# Product Change Notification

**Change Notification #:** 107519 - 00  
**Change Title:** Intel PRO/1000 MF Dual Port Server Adapter, PWLA8492MF MM#844141, PWLA8492MFBLK5 MM#847744 (Double Eldridge), PRO/10GbE CX4 Server Adapter, PXLA8591CX4 MM#874568 (Cedar Rapids), and PRO/1000 XF Server Adapter, PWLA8490XF MM#841553, PWLA8490XFPAK5 MM#841554 (Eldridge)

**Peoples Republic of China (PRC) Environmental Friendly Use Period (EFUP) Label, Recycle Label, Software Driver Update, Standardizing Common Clamshells, and Standardizing 3n1 Label Size**

**Date of Publication:** May 11, 2007

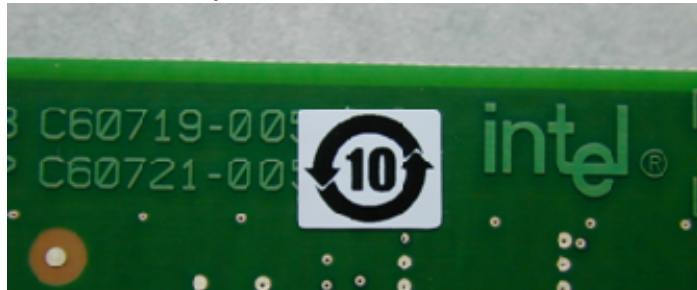
**Intel will add a PRC Environmental Friendly Use Period (EFUP) label on the Network Adapters:**

- PRC requires this EFUP label for control of Pollution caused by Electronic Information Products.
- This EFUP label will be placed on the secondary side of the adapter, **as shown in the pictures below**, the EFUP label could be placed in a slightly different location based upon space constraints. This label will include a 10 year use period for all Desktop adapters, or a 20 year use period number for all Server adapters.
- The products shown in the Affected Products Table, within this PCN notification, will include this new EFUP label.

**Recycle Label**  
size 45.00mm x 45.00mm, black ink

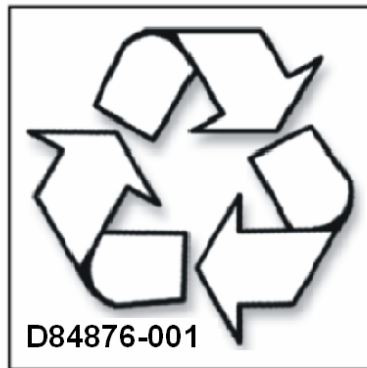
**Intel will add a Recycle Label to all of the Networking Adapter cardboard boxes:**

- Placement of this recycle label will vary based upon space constraints.  
**Recycle Label shown in the picture below.**
- All products shown in the Affected Products Table within this PCN notification will include this new Recycle Label.

**Picture of Large, Small and Med sized labels (example shows size of labels only, not exact placement)**

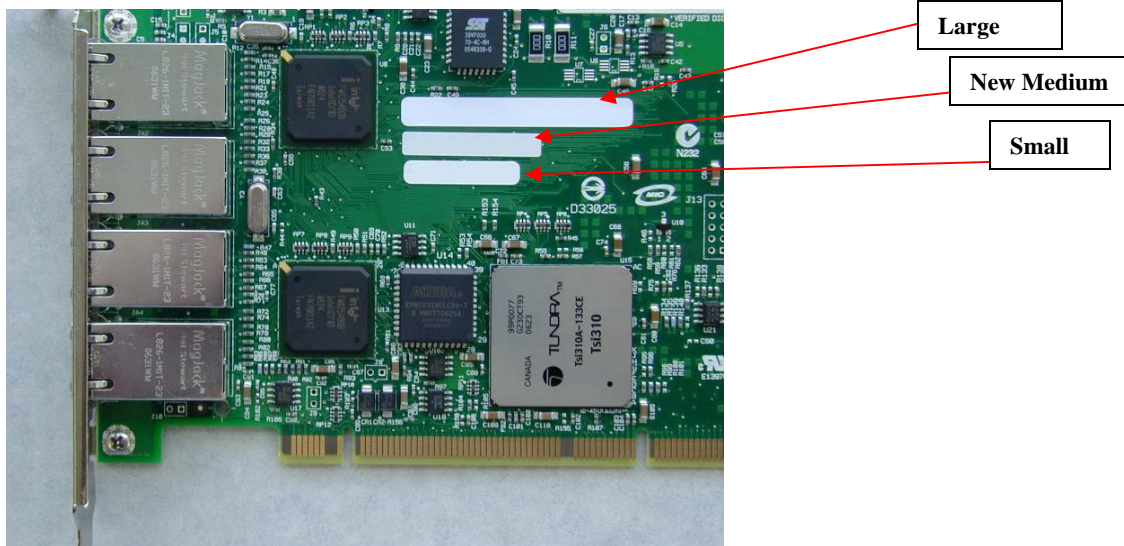
## Standardizing 3n1 Label Size:

- The 3n1 label, which is placed on the primary side of the adapter in the upper right hand corner, will change from either a Large label size of 2" x .25" or Small label size of 1" x .20" to a Medium label size of 1.2" x 0.20". This will not affect the label data in any way. **Please see picture below.**
- We recommend all customers enable their bar code scanners to Scanning Code 93 for the new Medium sized label.
- The products shown in the Affected Products Table, within this PCN notification, will include the new Medium 3n1 label size.
